APPLICATION NO.	FILING DATE	FIRST NAMED INVENTOR	ATTORNEY DOCKET NO.	CONFIRMATION NO.
10/736,947	12/16/2003	Richard C. Chu	POU920030165US1	5523

Office Action Summary

DETAILED ACTION

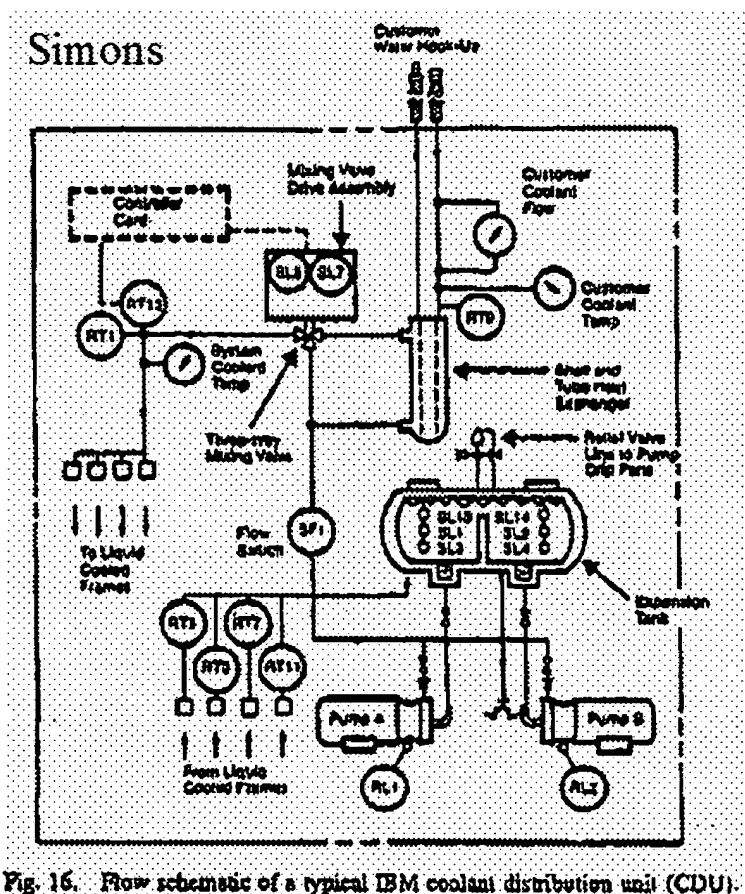
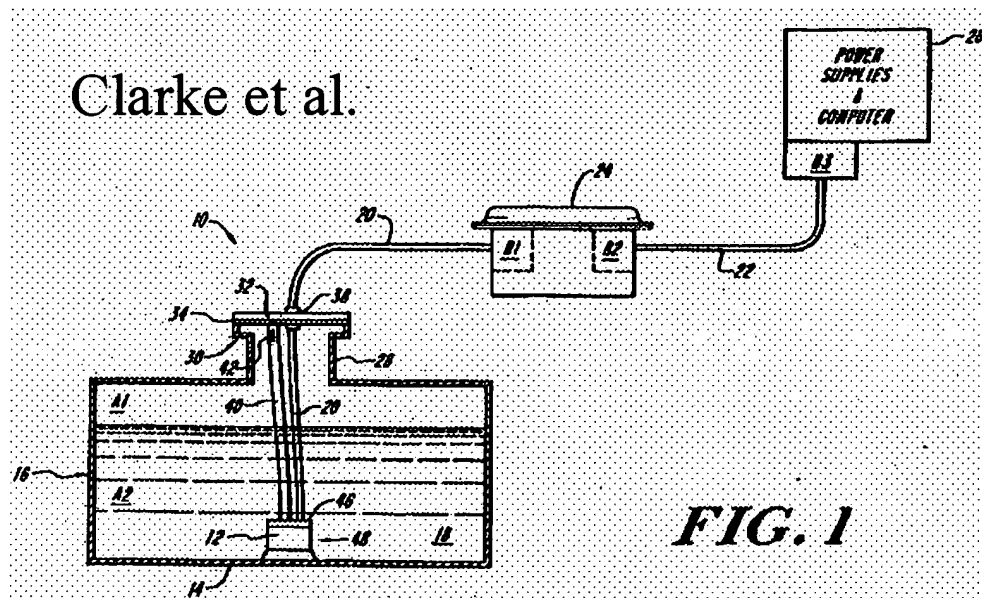
4. Claims 1, 2, 7-10, 15-18 and 20 are rejected under 35 U.S.C. § 103(a) as being unpatentable over Applicant's disclosed Prior Art document "The Evolution of IBM High Performance Cooling Technology" by Simons (hereinafter Simons) and US 5,245,869 to Clarke et al. (hereinafter Clarke). Simons discloses various apparatus/system and methods of monitoring coolant with a cooling systems, including water cooled systems (Section IV) (Fig. 16) which circulate and control the temperature of cooling water with a cooling distribution unit (CDU) including the elements of heat exchangers, temperature controllers, pumps, expansion tanks and water supply/return manifolds and the importance of all these elements to function properly and provide uninterrupted operation ensuring adequate cooling levels. Simons fails to disclose monitoring the coolant employing at least one pressure transducer to obtain multiple pressure measurements related to an amount of coolant within the expansion tank, determining a rate of volume change of coolant with the expansion tank employing the multiple pressure measurements (as recited in claims 1, 9 and 17); the measurements being successive pressure measurements at known time intervals and related to the amount of coolant in the expansion tank, thus determining the rate of volume change of the coolant with the expansion tank (as recited in claims 2, 10 and 18); an wherein the pressure transducers are differential pressure transducers (as recited in claims 7, 8, 15, 16 and 20). Clarke teaches a method of monitoring the amount (i.e. level) of liquid within a tank (Figs. 1-5) employing a differential pressure transducer (12) monitoring the amount of fluid above the transducer which is located at the bottom of the tank, making pressure measurements to determine an amount in the tank and a "loss rate" for leak detection (i.e. measurements over time periods, iterations) (Clarke: col. 5, lines 5-10 and col. 7, lines 30-33). It would have been obvious to one having ordinary skill in the art at the time

the invention was made to employ pressure transducers to monitor the amount of coolant in the tank and all the recited method steps, as taught by Clarke, modifying the method of monitoring coolant within a cooling system disclosed by Simons, thus providing a high resolution and highly accurate sensor and system for monitoring the amount of coolant in the tank for safe, uninterrupted operation of the cooling system (Clarke: col. 1, lines 37-40). Lastly, specifically regarding claims 17 and 20, the provision of providing a program or computer readable medium employing the method /program/instruction steps disclosed by Simons and Clarke is well within the level of one of ordinary skill in the art, and fails to meet any novelty requirement.

Koizumi et al.

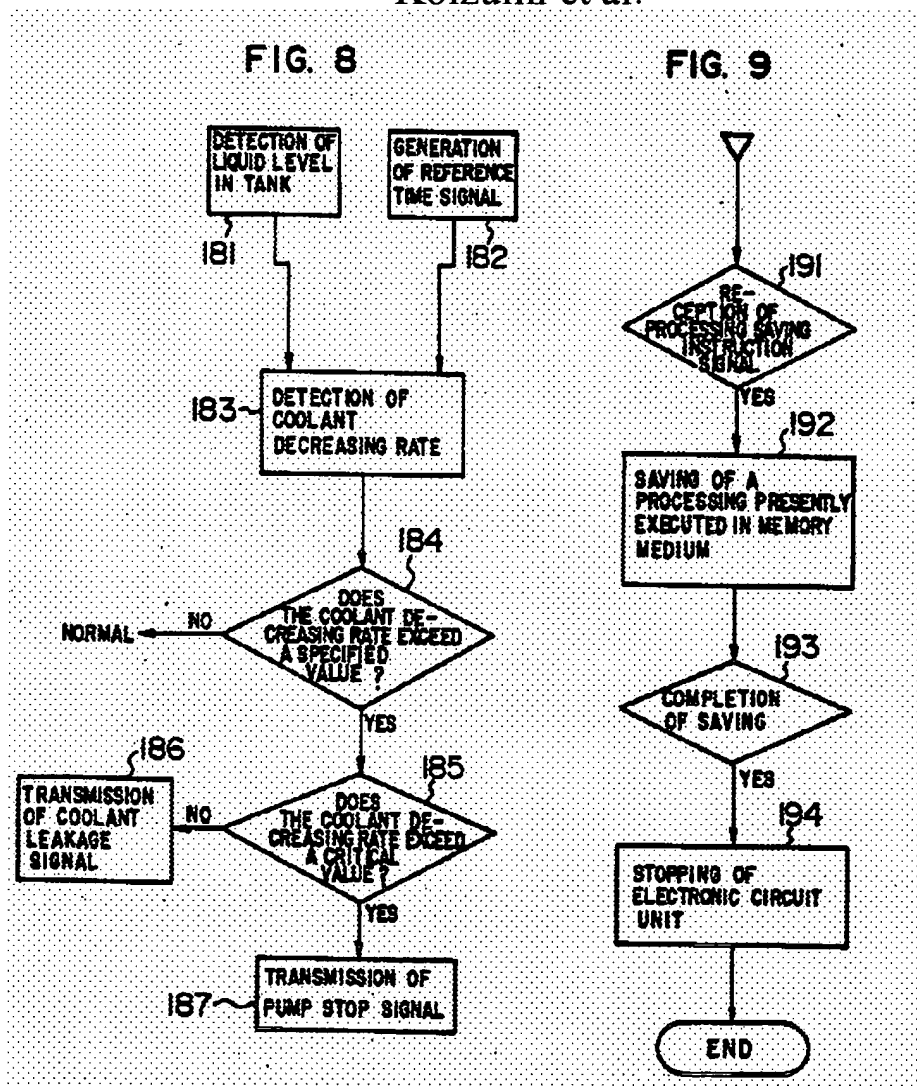
5. Claims 3-6, 11-14 and 19 are rejected under 35 U.S.C. § 103(a) as being unpatentable over Simons and Clarke as applied to claims 1, 9 and 17 above, and further in view of US 5,323,847 to Koizumi et al. (hereinafter Koizumi). Simons and Clarke disclose an apparatus/system and method of monitoring coolant within a cooling system having all of the elements and method steps recited previously. Simons and Clarke do not expressly disclose the employment of determining an immediacy of action to be taken to service the cooling system based on the rate of volume change within the expansion tank (as recited in claims 3, 11 and 19); and the employment of specific leak rate set points/thresholds that are exceeded or fall below particular levels of coolant within the coolant tank (as recited in claims 4-6 and 12-14). Koizumi teaches the monitoring of coolant levels for the cooling of an electronic apparatus (Figs. 1-14) wherein the amount (i.e. liquid/water/coolant level) is monitored at particular set points and thus actions (i.e. alarms/indicators) are actuated to inform an operator to take necessary action such as stopping the operation of the electronic unit or inspecting the coolant (see Fig. 8 below)

(Koizumi: cols. 8-11). It would have been obvious to one having ordinary skill in the art at the time the invention was made to employ limits/set-points to indicate immediacy of action to an operator and other obvious variants as recited in the instant claims, as taught by Koizumi, thus modifying the monitoring of coolant with a cooling system disclosed by Simons and Clarke, thus providing protection means alerting an operator to shut down the electronic unit associated with the cooling system.
